MEMORANDUM

SUBJECT: Steeple Chase: Amendment of Approved Preliminary Subdivision Plat / Special Exception Use Permit for a Residential Planned Development Project (PDP)
PID: 273012000000033020, 273012000000034000,
273012000000041010, 273012000000041030, 273012000000014010,
273012000000023030, 273012000000023010
PUBLIC HEARING – Requirements have been met.

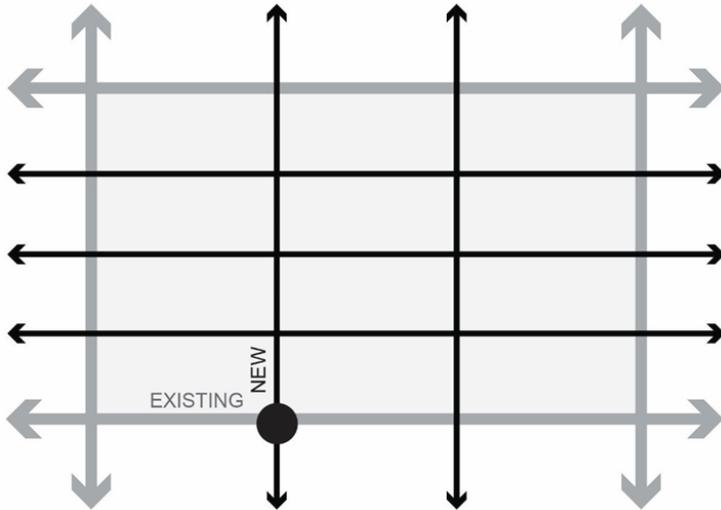
Staff comment: Street interconnectivity is achieved.

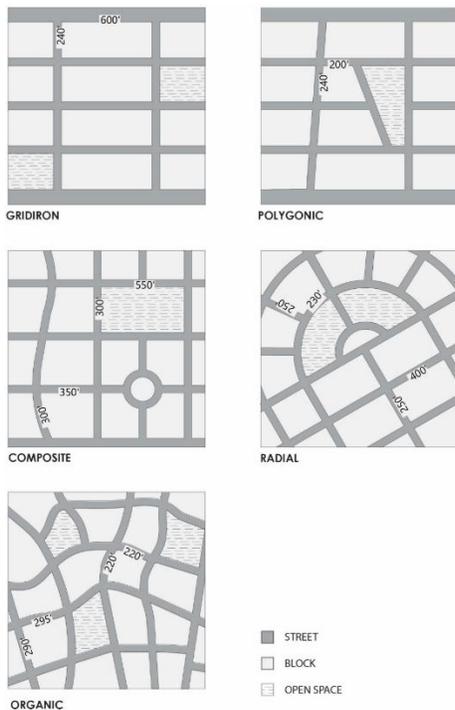
Staff comment: Street patterns vary.

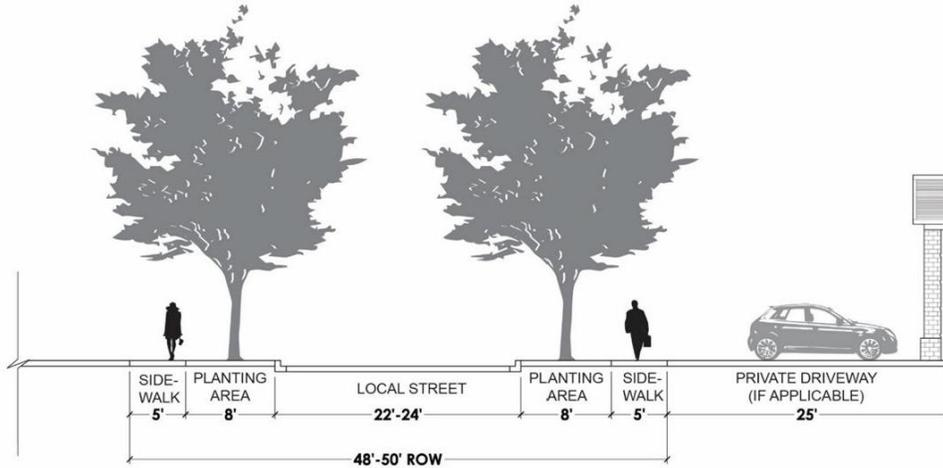
Staff comment: Sidewalks are proposed on both sides of the streets.
